Network FMC Errata

V1.0

13 February 2020

Figure 3 – D6 and Q1 DNP Location

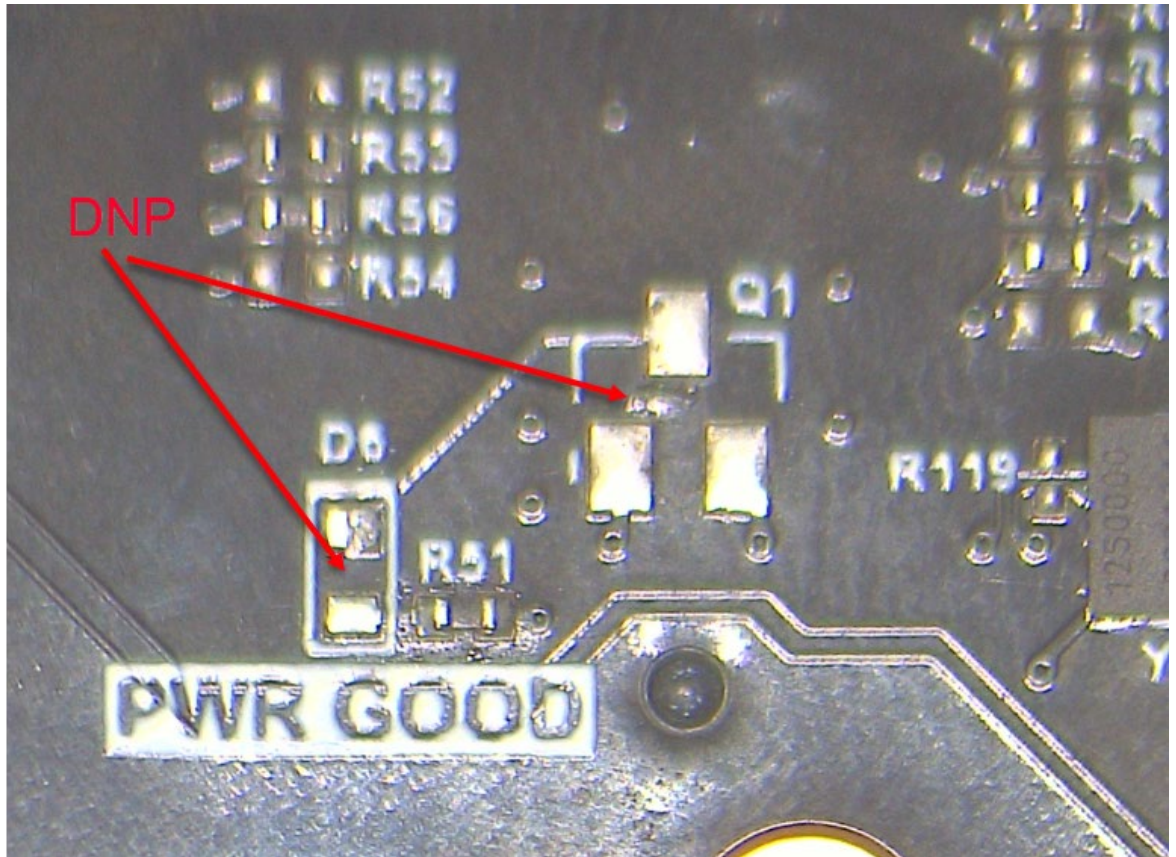
1. Remove the Transistor Q1.
2. Optional – Remove Led D6

3. Please note, PWR_GOOD Led will no longer work, but the board will now be compatible with Zynq 7000 baseboard.
